MEMORANDUM

FROM: Peter Wokral, Heritage Planner

DATE: February 10, 2021

SUBJECT: Committee of Adjustment and Site Plan Control Applications
14 Ramona Boulevard, Markham Village Heritage Conservation District
Proposed New Dwelling, Severance and Variances
B/07/18, A/95/18, and A/96/18

Proposed Severance

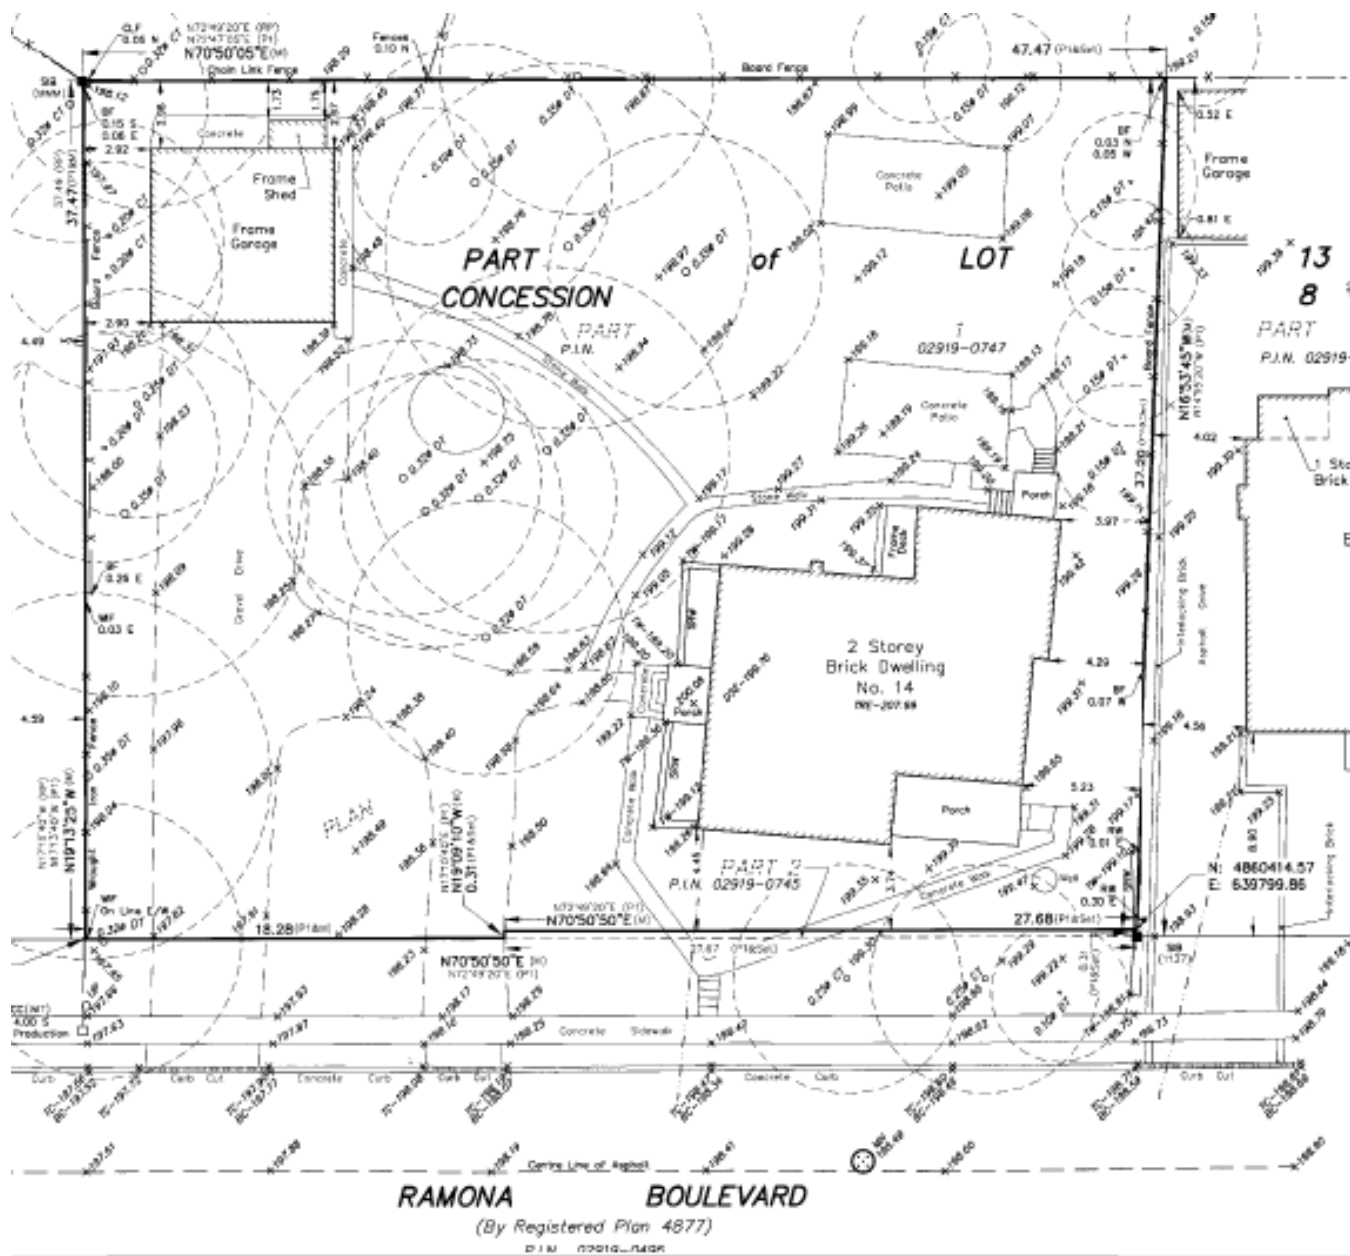
- Compared to the previous concept, the current proposal offers a number of improvements:
 - Lot Size and Configuration
 - Although the current large lot occupied by the Robinson House would be reduced in size, the proposed severance could be said to still maintain a variation in lot size and configuration (in comparison with the previous proposal). The heritage house would remain on the larger lot;

- Due to the proposed narrow frontage of the new lot, the proposed severance better retains views to and from the Robinson House to Ramona Boulevard and the existing context and features of the site. This is important as the principal façade of the Robinson House faces west;

- The proposed severance creates better amenity spaces for both the conveyed and retained lot than the previous proposal;
 - Driveway Placement and Tree Preservation

- The proposed new driveway leading to the new accessory building on the retained lot makes use of an already existing driveway, requires no new curb cuts and does not necessitate the removal of trees along the eastern property line or place two

Perspective View of Proposed New Dwelling on Conveyed Lot

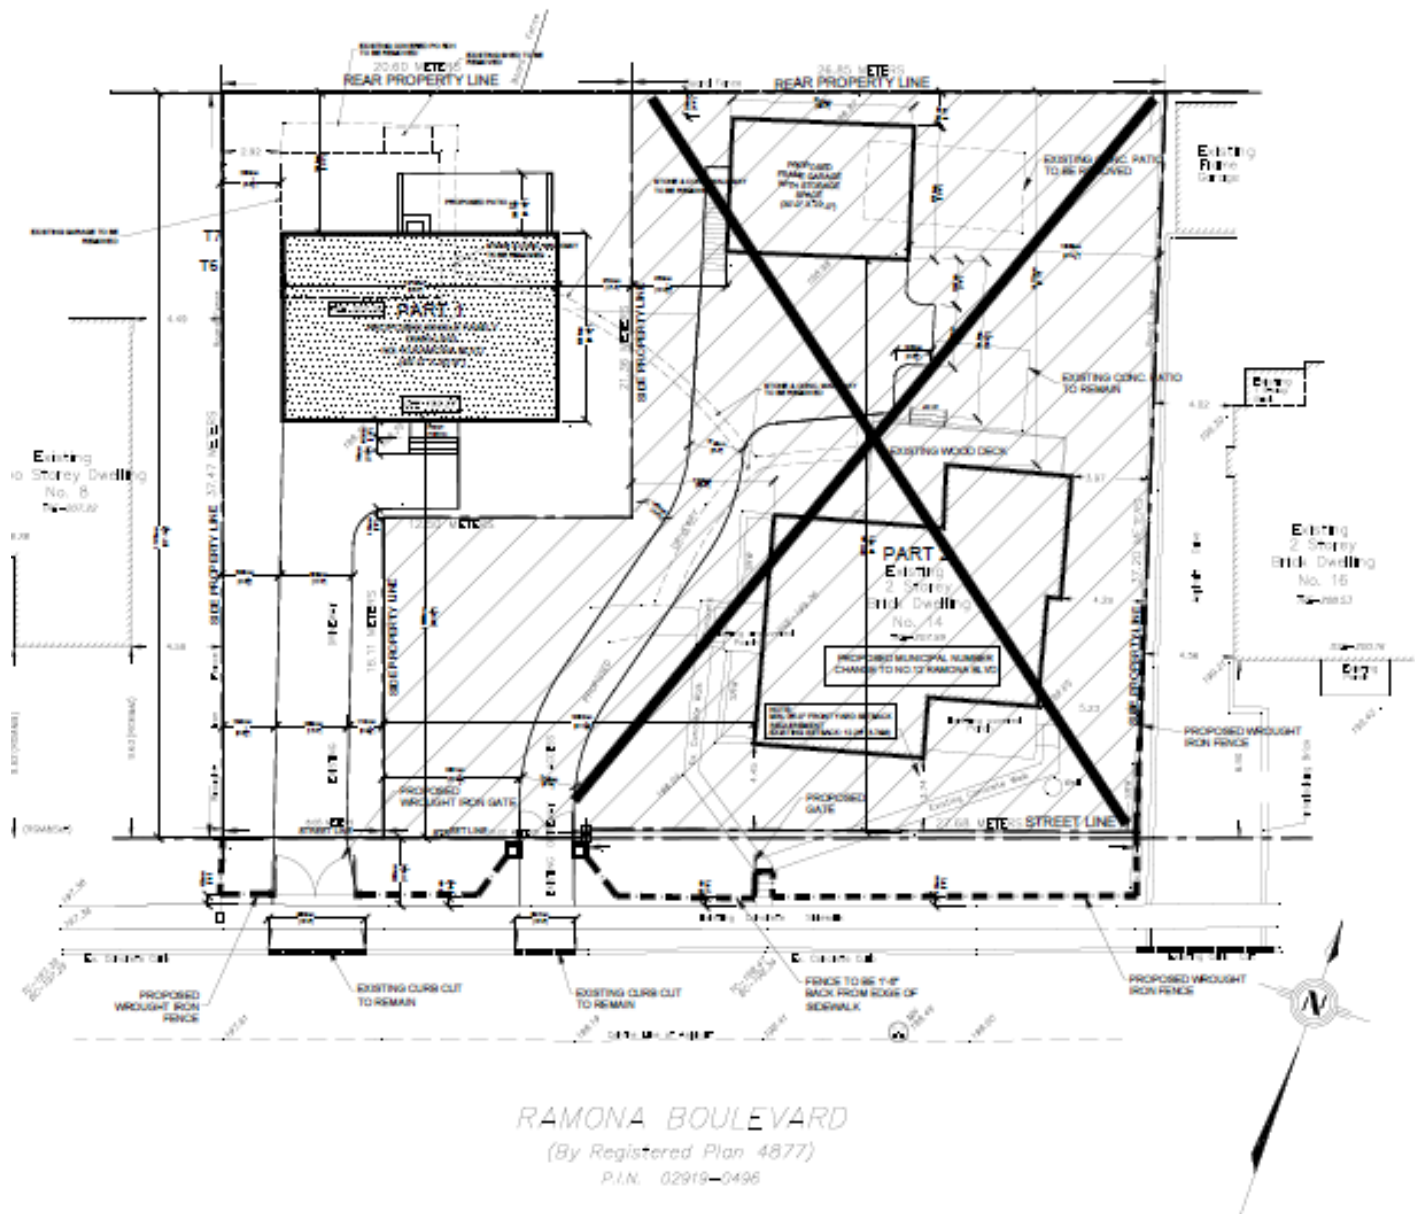
- The proposed new building on the conveyed lot is of a scale, and setback to the existing Robinson House that is subordinate to the main house and more authentically resembles an accessory building;

- In particular, staff would recommend changes to the design and specifications of the proposed windows of both these buildings intended to make them more historically authentic in terms of method of operation and pane divisions;

- That the size, scale and architectural designs of the proposed new dwelling on the conveyed lot and the proposed new accessory building on the retained lot reflect the concept drawings attached to this application subject to minor improvements of the architectural details and window specifications etc
- That any fence in the front yard of the conveyed lot (which will be the side yard fence of the retained lot) be a wooden picket or wooden rail fence no higher than 42 inches to allow continual views of the front elevation of the Robinson House; and
- That Site Plan Approval is obtained for the proposed new dwelling (conveyed lot) and accessory building (retained lot) containing standard clauses regarding colours, materials window treatment, etc.;

Proposed New Accessory Building for the Retained Lot

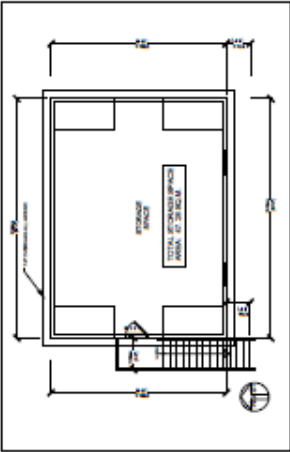
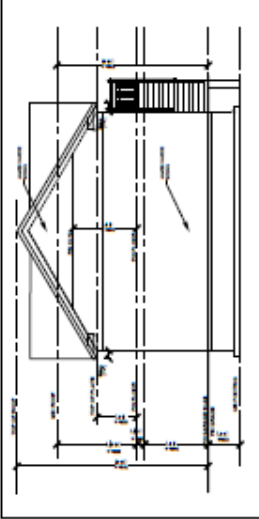
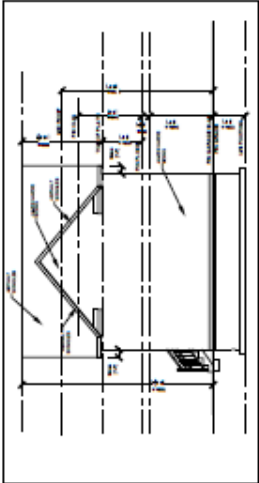
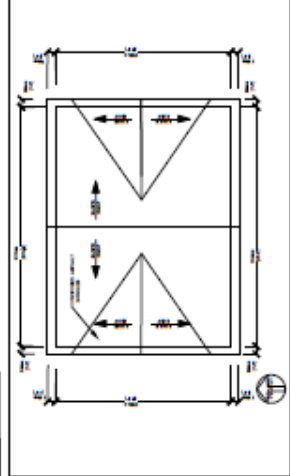
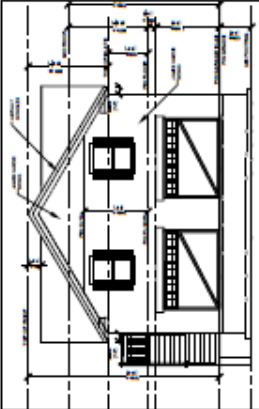
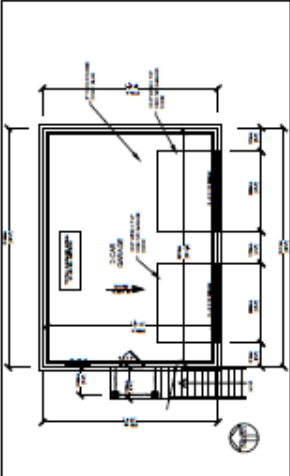
- The proposed new accessory building for the retained lot is more authentic looking than the previous proposal and is lower in height and requires no variances for the setbacks to the side and rear property line;
